Project Name: Sexton Auditorium

Project No.: 221125-180

Date: 12/11/2025

This Addendum is issued to inform the bidders of modifications in the scope of work being bid for this project.

RFI #13: Aisle Lights in New Seating - Auditorium

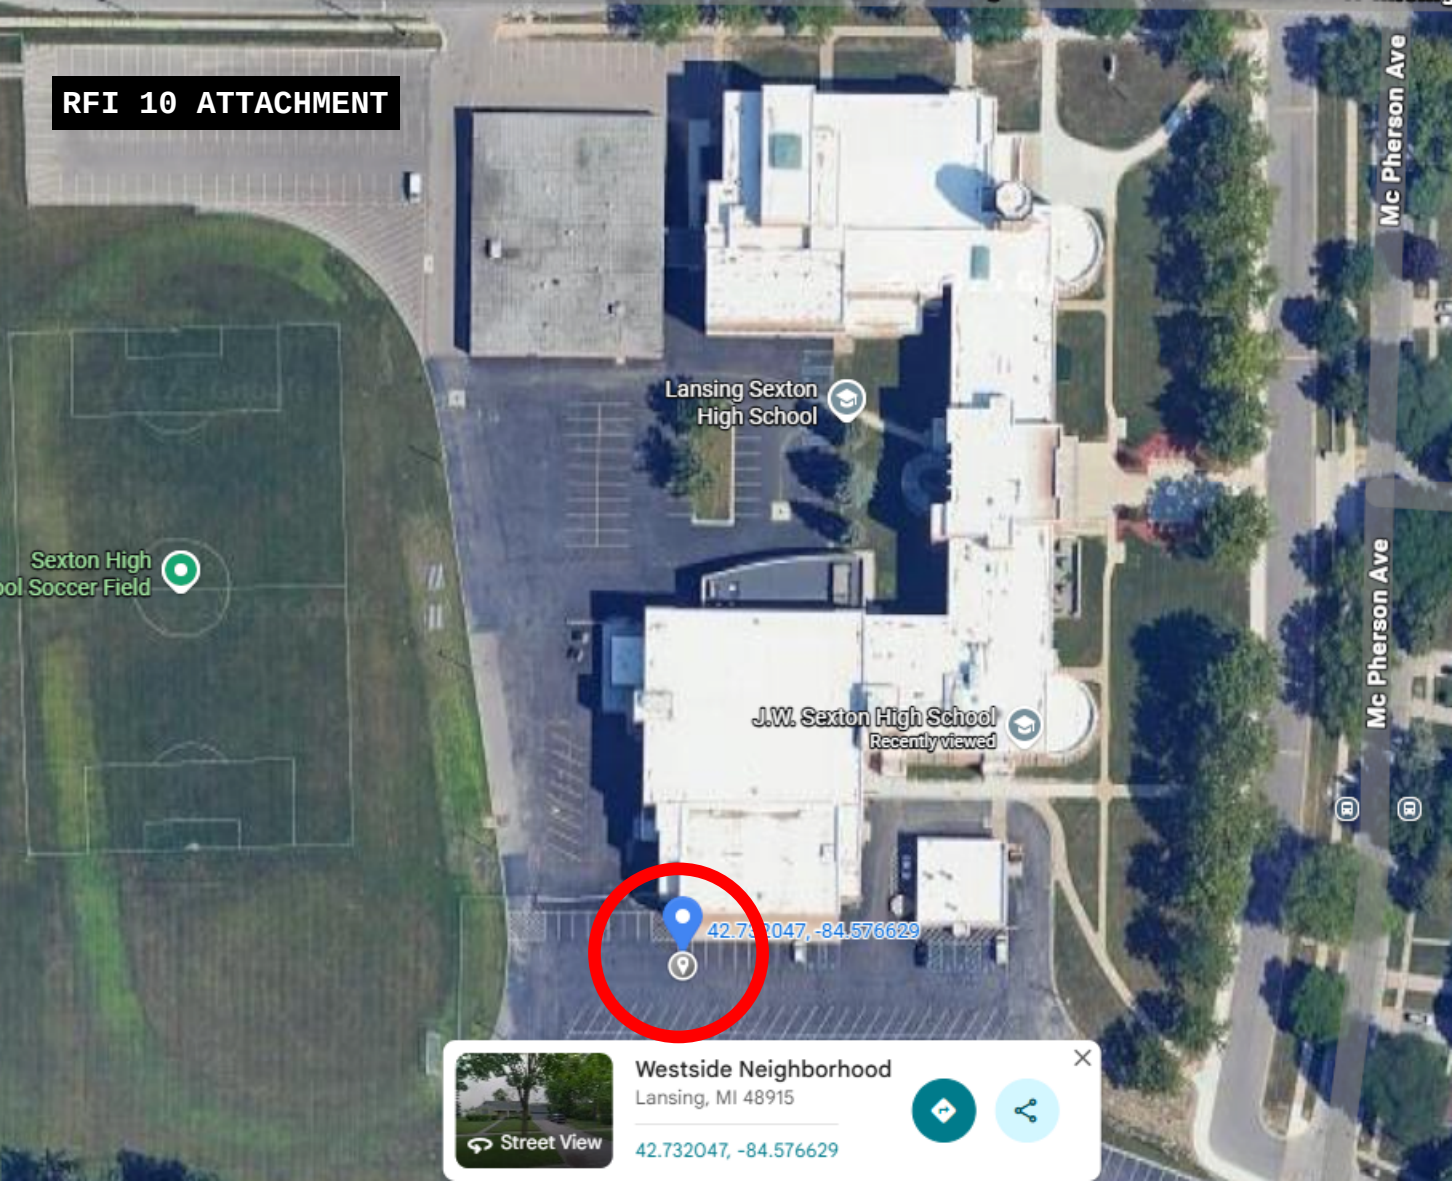
Please verify if new seating is to have aisle lighting in them, existing has some but it does not seem compatible with the new design. Please affirm if new seating is to receive lighting or not.

The new seating does not have integral aisle lighting in the end stanchions.

Drawing No. 2: FrameALL Soffit System Details.

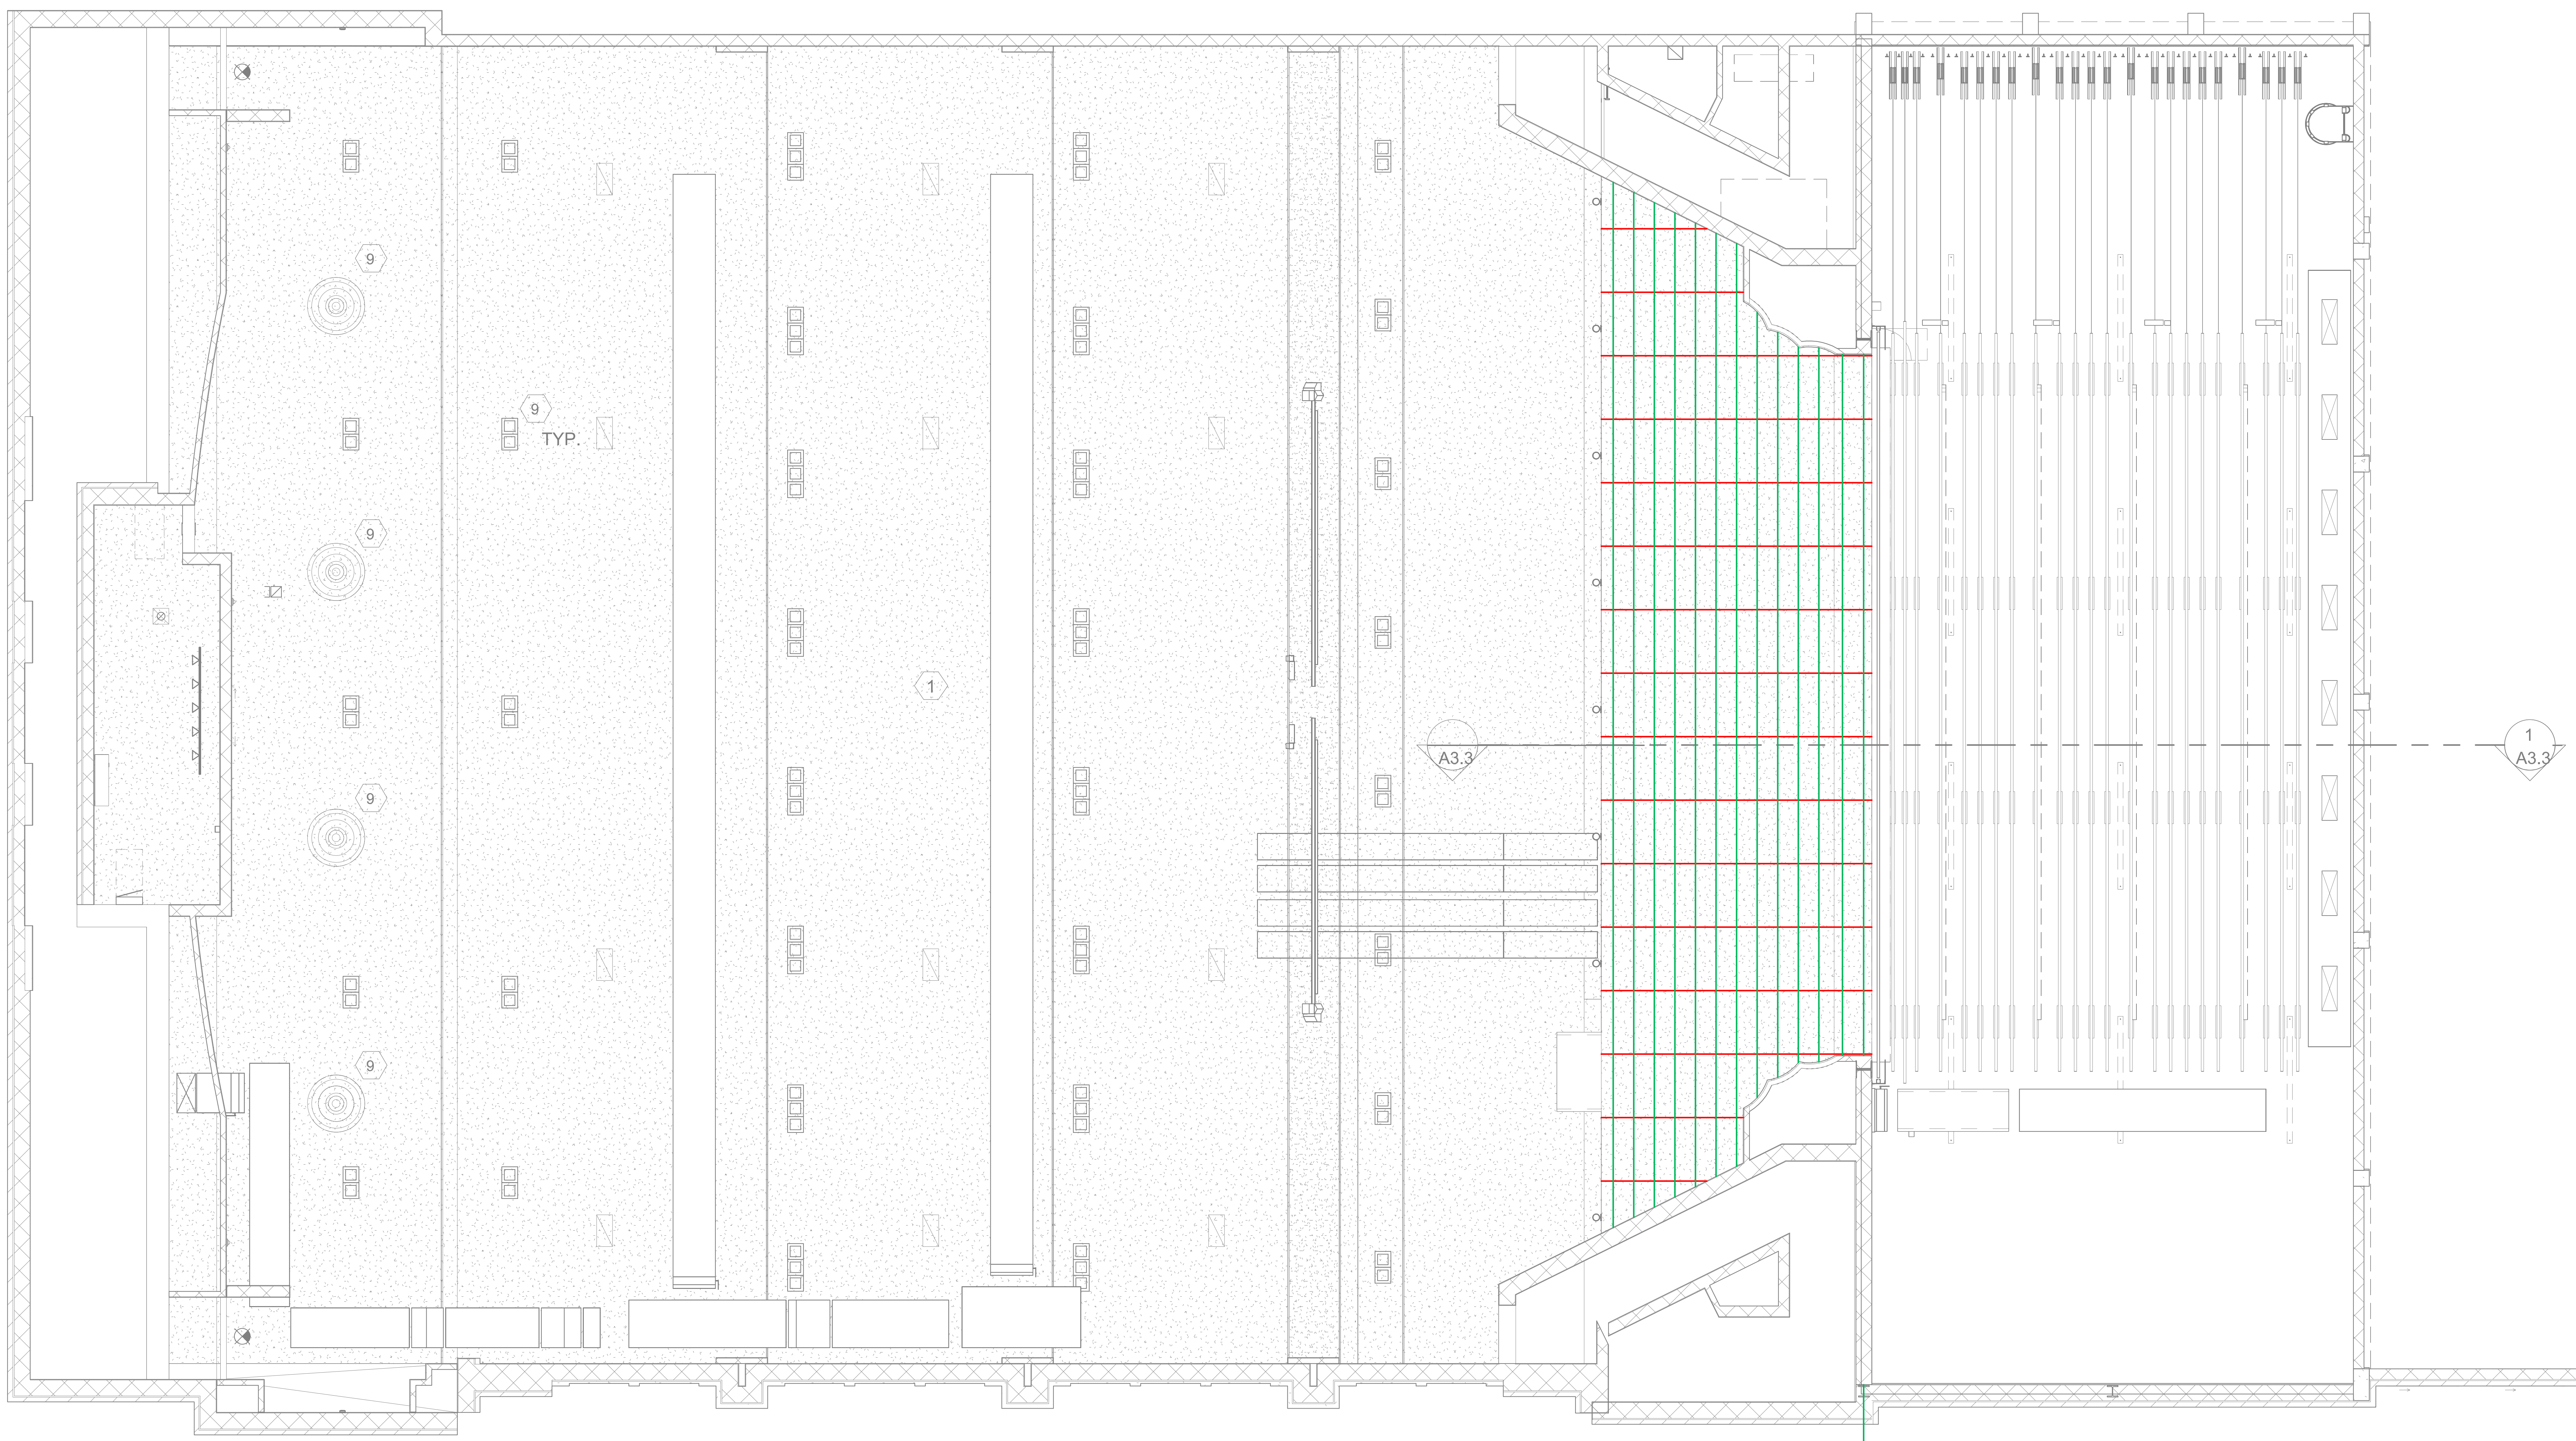
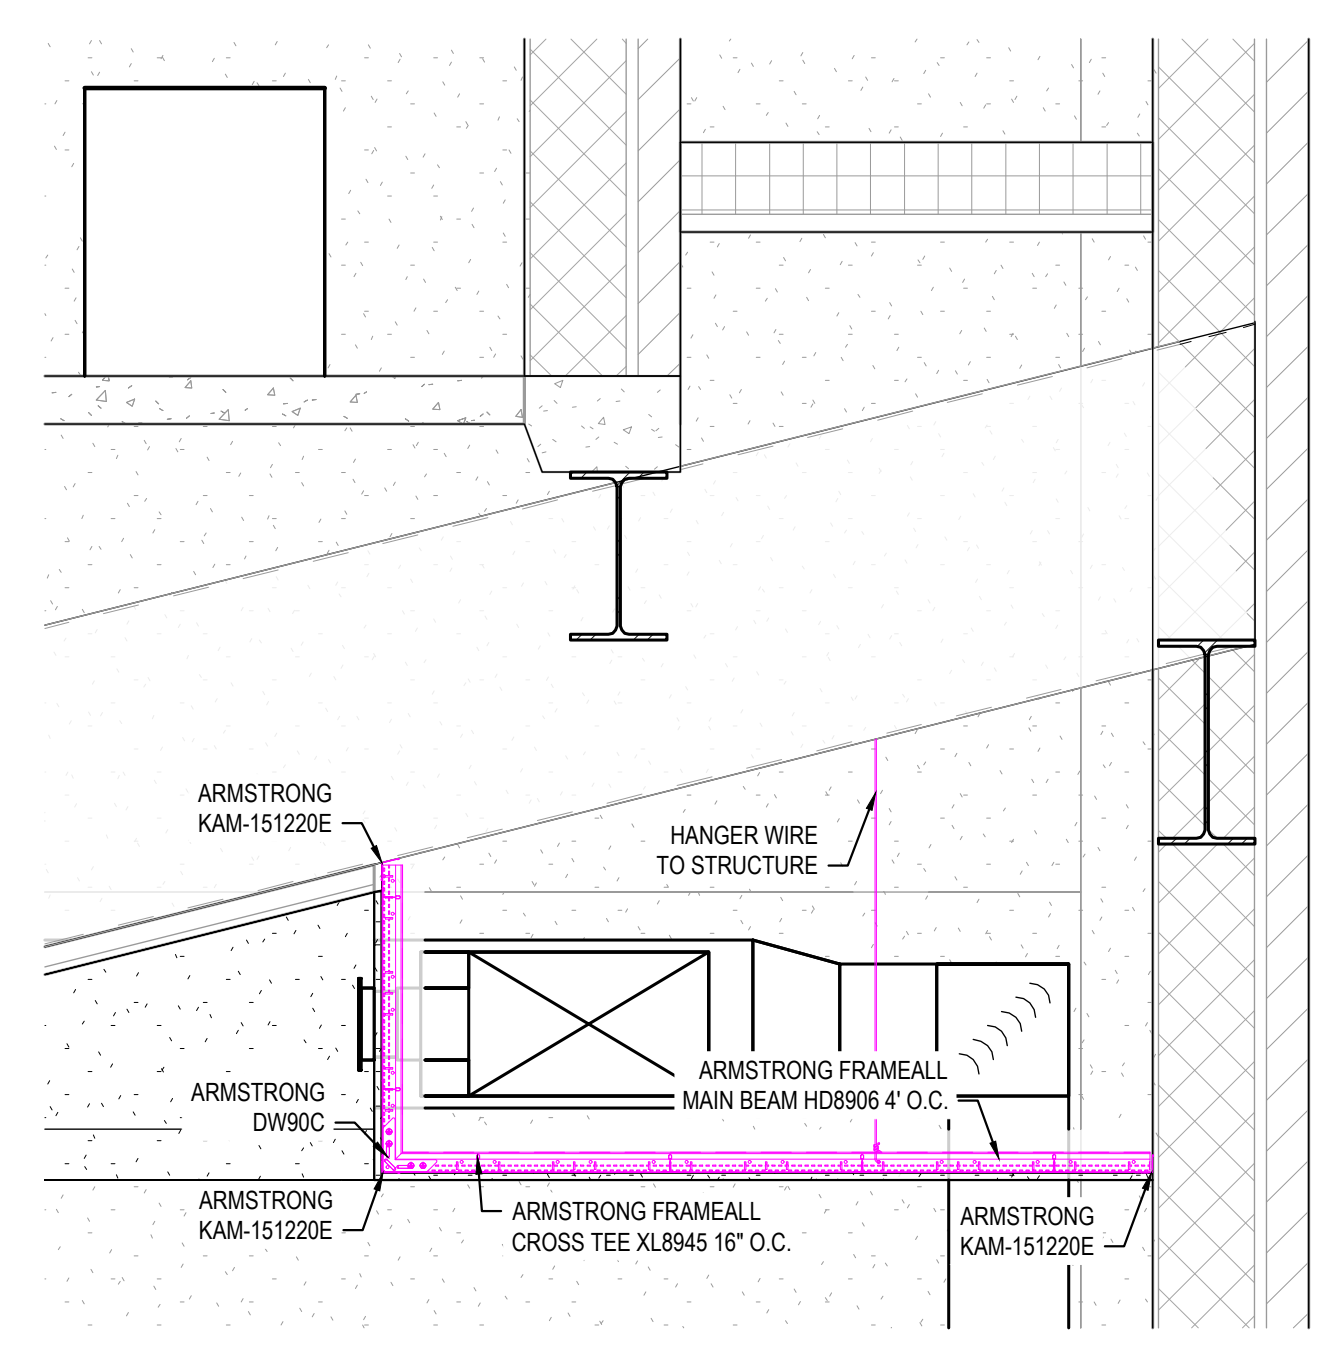
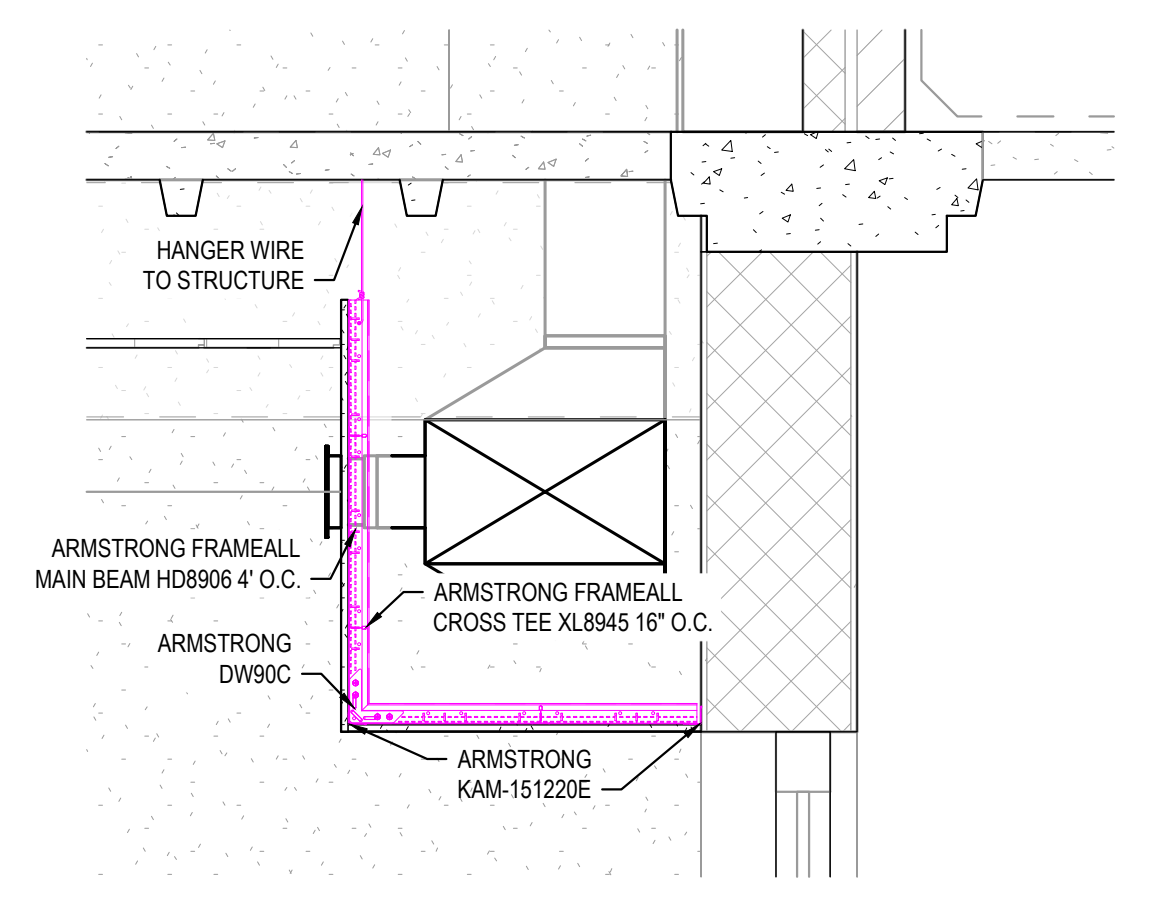
1. Provide Armstrong FrameALL framing system in lieu of conventional stud framing. See supplemental drawing No. 1 for additional information.
